TOWN OF CORTLANDT PLANNING BOARD

MEETING AGENDA.....PLANNING BOARD TOWN OF CORTLANDT 6:30 TUESDAY EVENING* SEPTEMBER 10, 2024

- PB 2024-1** a. Public Hearing: Application of KPB Properties LLC for Site Development Plan approval and a referral from the Town Board of a Petition for a Zoning Text Amendment for a proposed 4-story, 75,000 sq. ft. self-storage facility located at 3 Locust Avenue. Drawings latest revised August 22, 2024.

SITE LIGHTING PLAN

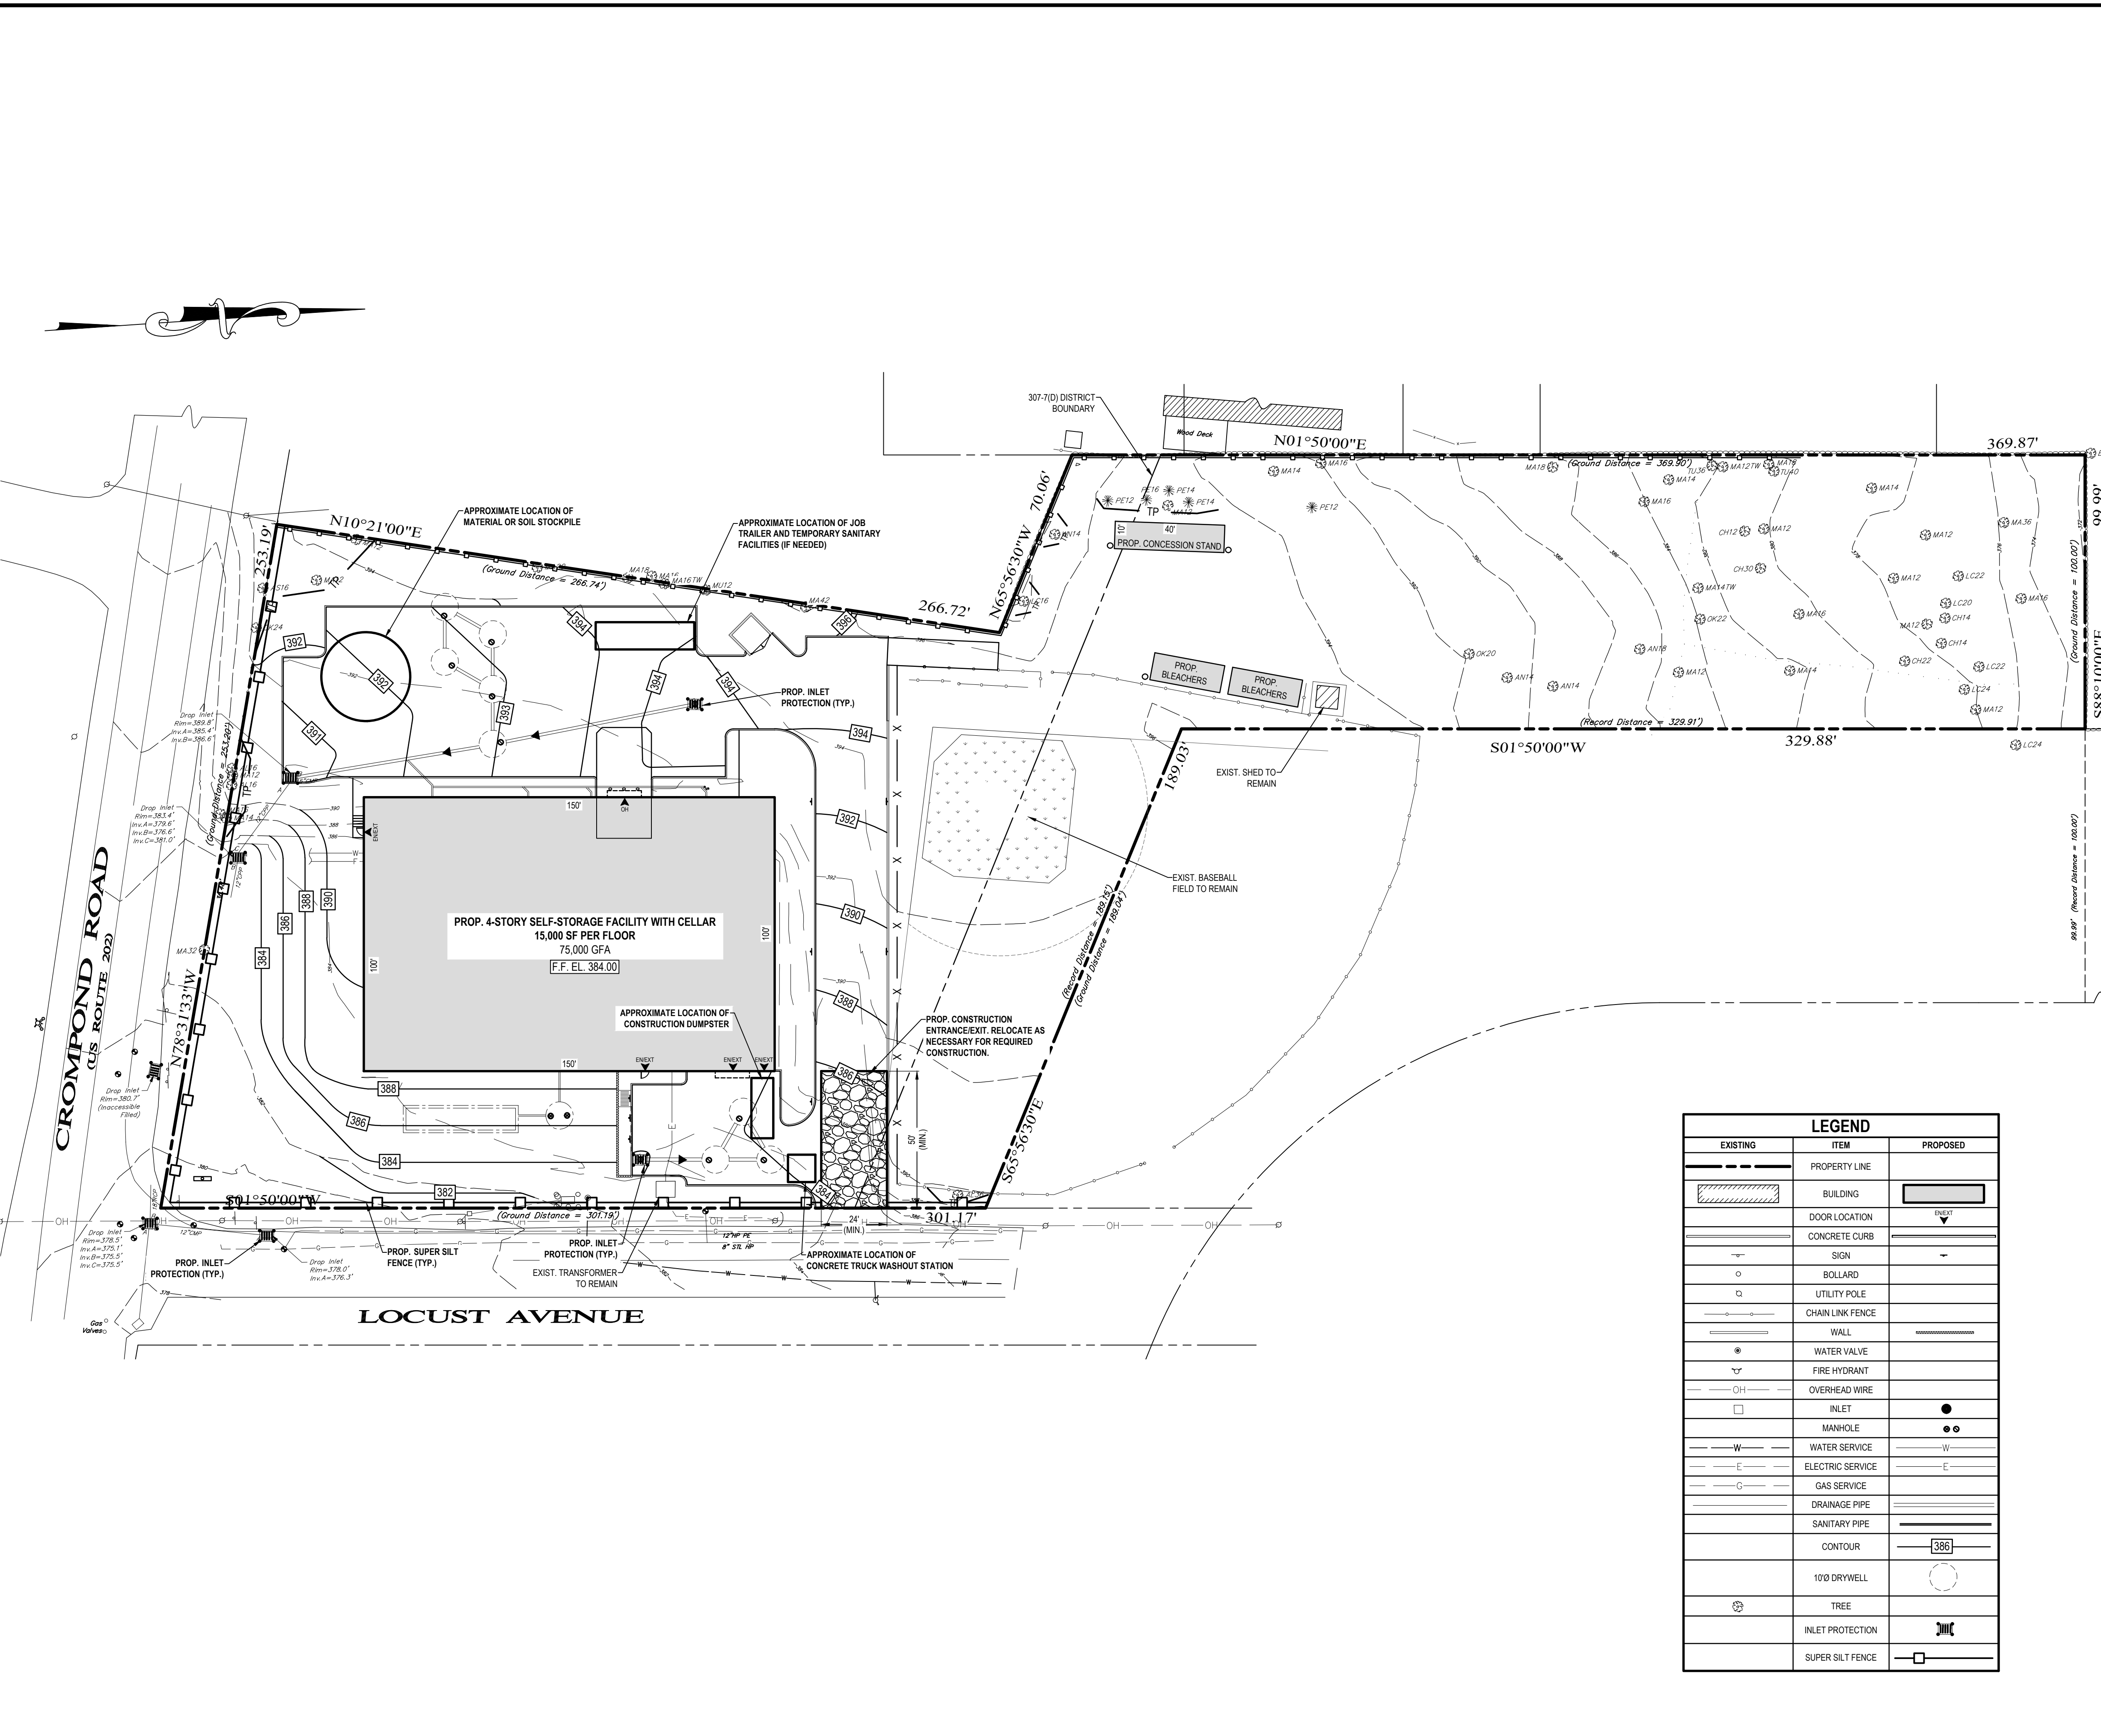
21. *Sheet C-6 – illumination is shown as spillage on adjacent roadways and properties, is this due to existing street lighting?*

Response: The existing street lighting was not factored in the lighting analysis depicted on Sheet C-6. Note that the illumination levels that “spill” onto the adjacent roadways are only near the sites entrance and are all under 0.7-foot candles.

DRAWING No: **C-10**

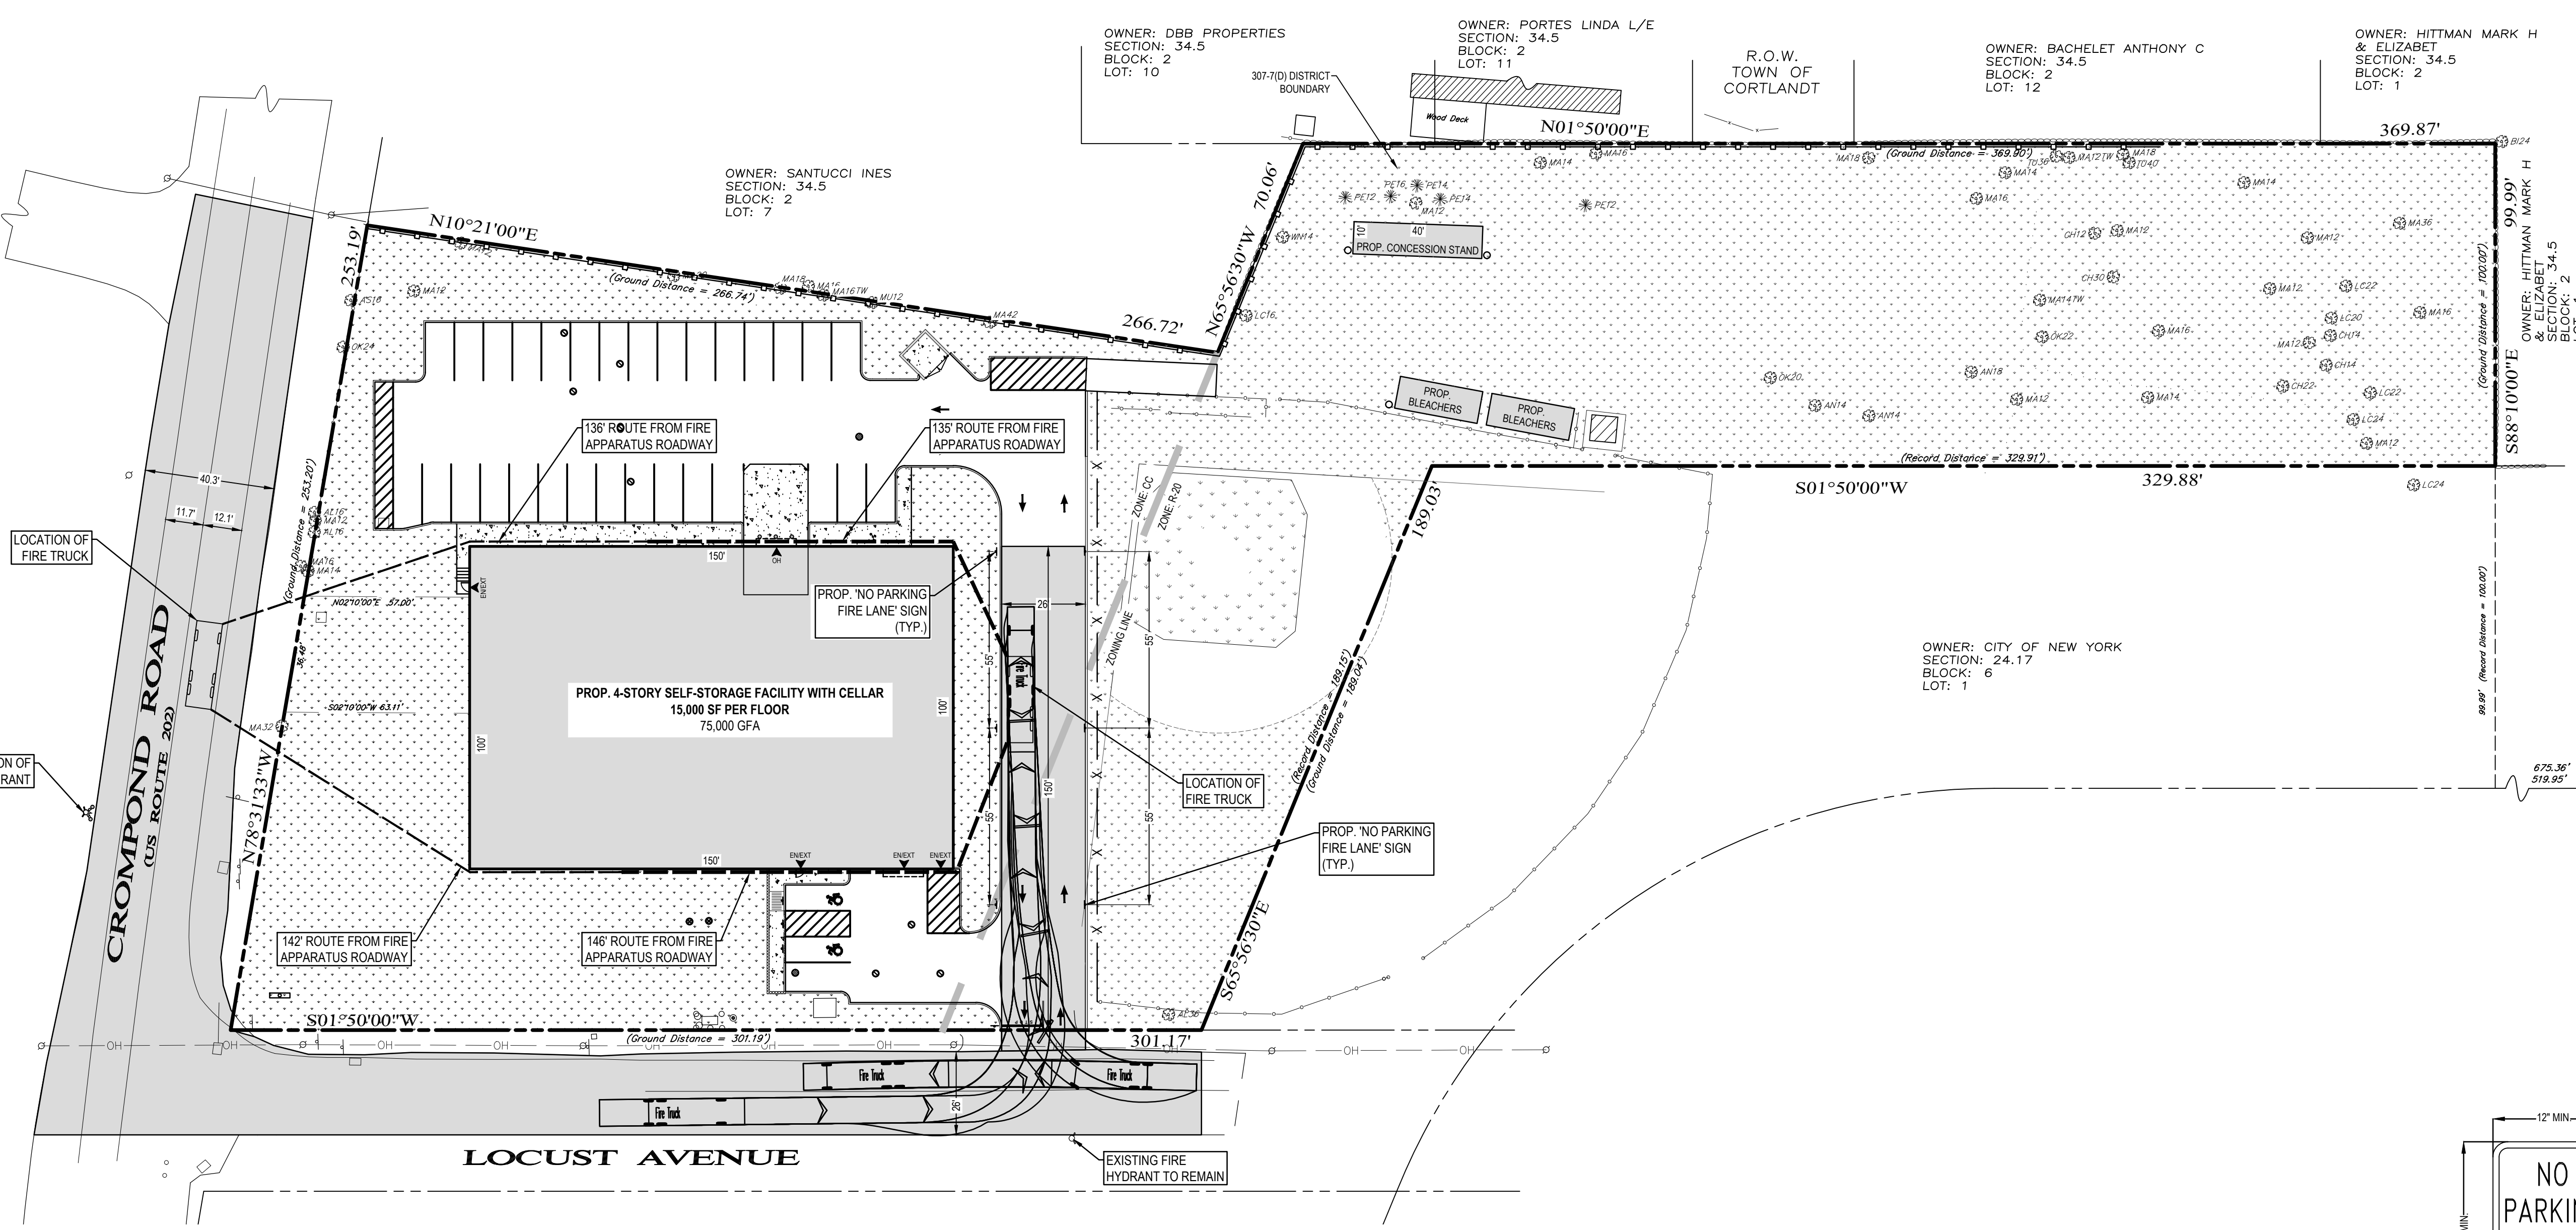
24. *Sheet C-9 – ensure typical details conform to Town standards and are in accordance with the standards set forth by D.O.T.S.*

25. *Sheet C-9 – Include inlet and outlet, and bottom elevations on the drywell detail.*

26. *Sheet C-9 – Revise the porous paver and drywell detail to indicate the required 3-foot separation to groundwater.*

Response: The inlet, outlet, and bottom of elevations are provided on Sheet C-3 on the drainage structure schedule.
